SUNDRY NOTICES AND REPORTS ON WELLS
Do not use this form for proposals to drill or to re-enter an abandoned well. Use Form 3160-3 (APD) for such proposals.

8. Well Name and No.
WLH G4S Unit No. 40

9. API Well No.
30-015-37024

EnerVest Operating, LLC proposes to plug and abandon this well with procedure as follows:

Proposed P&A Wellbore Schematic

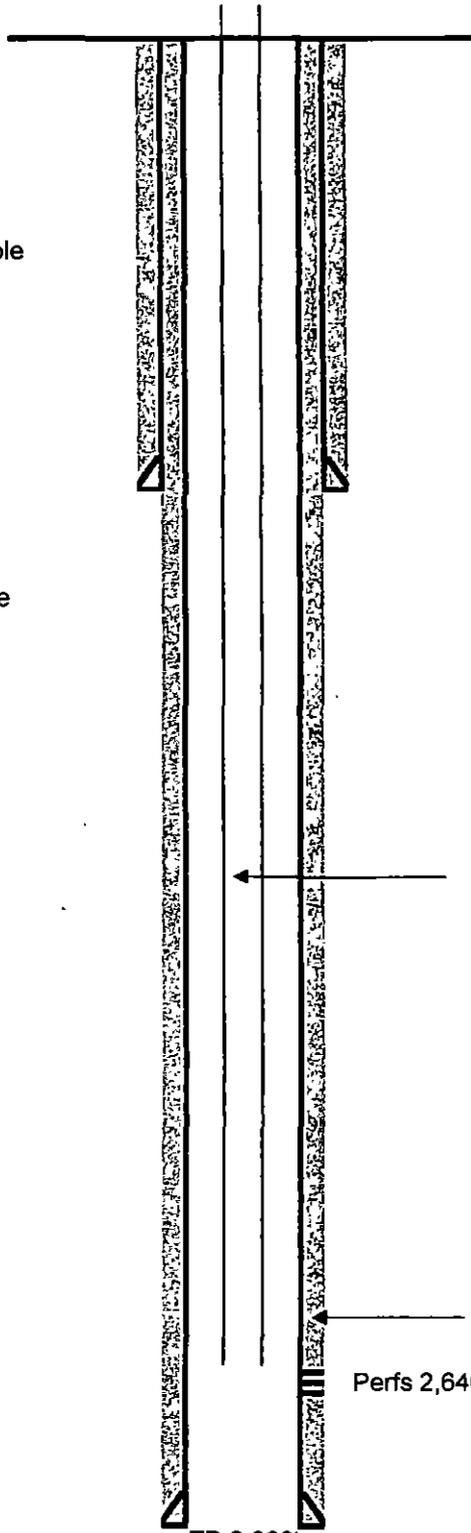
CMT Plug @ 447'-200' *WOC + Tag*

1350-1100
CMT Plug 1500-1250' *WOC + Tag*
